**County of Loudoun**  
**Office of Transportation Services**  
**MEMORANDUM**

**SUBJECT:** ZMAP 2006-0011, ZCPA 2006-0003—Stone Ridge Commercial  
Second Referral

Figure 4  
Existing Lane Use and Traffic Control and  
Peak Hour Levels of Service

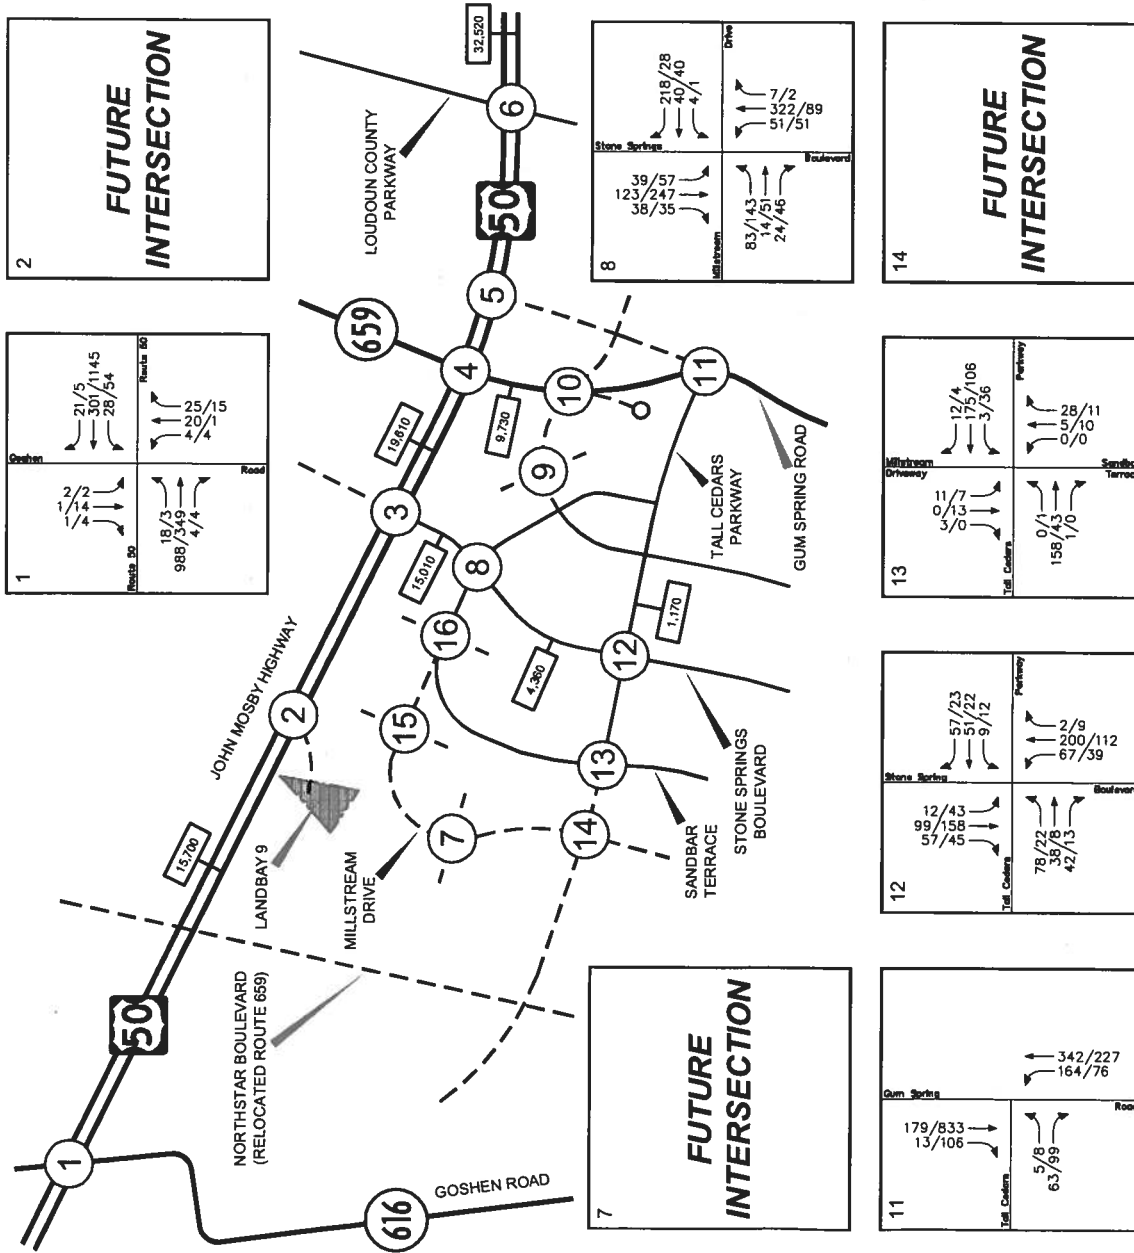
*Attachment 5 (Column 1)* summarizes existing intersection LOS in the vicinity of the site. Under existing signalized control, both the Route 50/Stone Springs Boulevard intersection (Intersection 3) and the Route 50/Route 659 intersection (Intersection 4) operate at an overall unacceptable LOS in the AM peak hour, though certain individual movements at each

intersection operate at unacceptable LOS in the PM peak hour. The Route 50/Loudoun County Parkway intersection (Intersection 6) operates at overall unacceptable LOS conditions in both the AM and PM peak hours with existing signalization.

Figure 7  
Future Proposed Lane Use and Traffic Control and  
Peak Hour Levels of Service

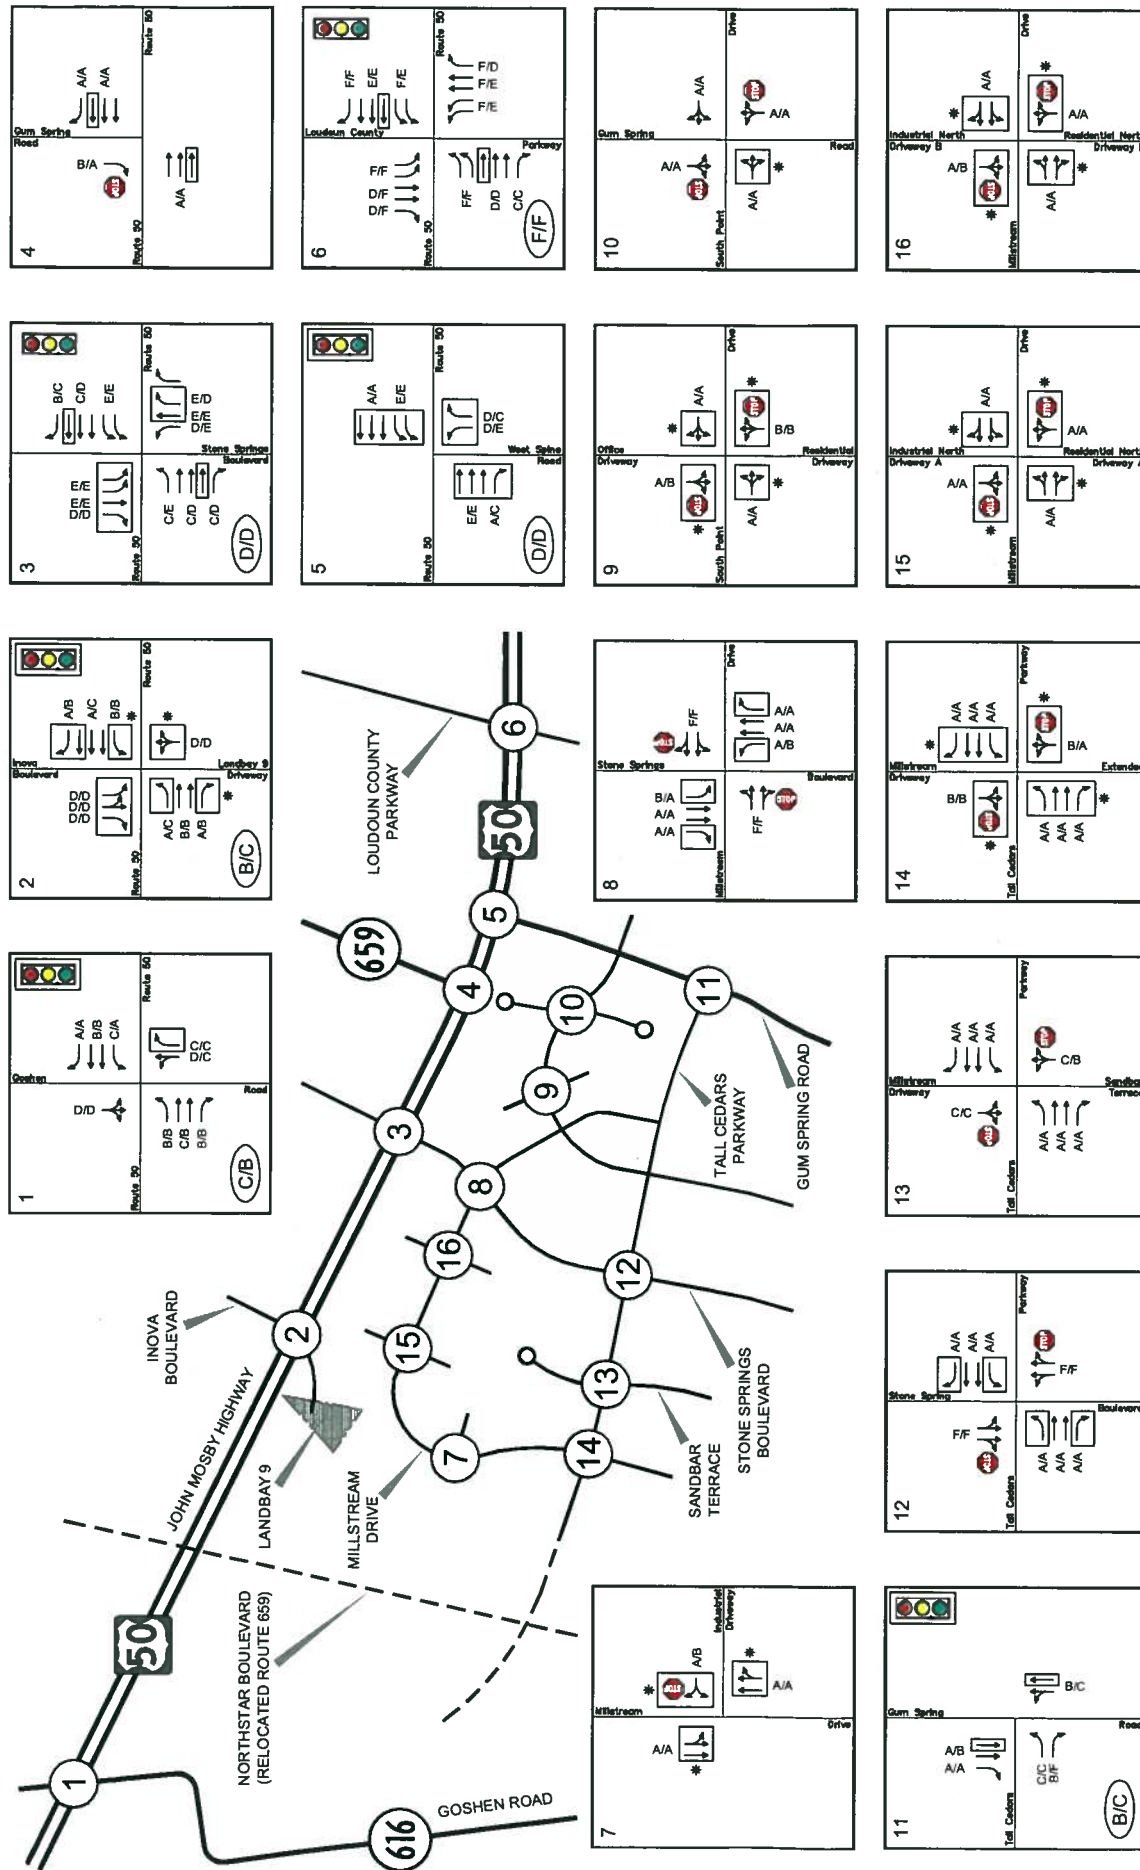
10. The Applicant should commit to implement/construct the on-site “proffered” and “site” improvements identified in the updated traffic study for the proposed development program (see *Attachment 10*). The study indicates that these improvements are necessary to realize the forecasted peak hour intersection LOS conditions presented.
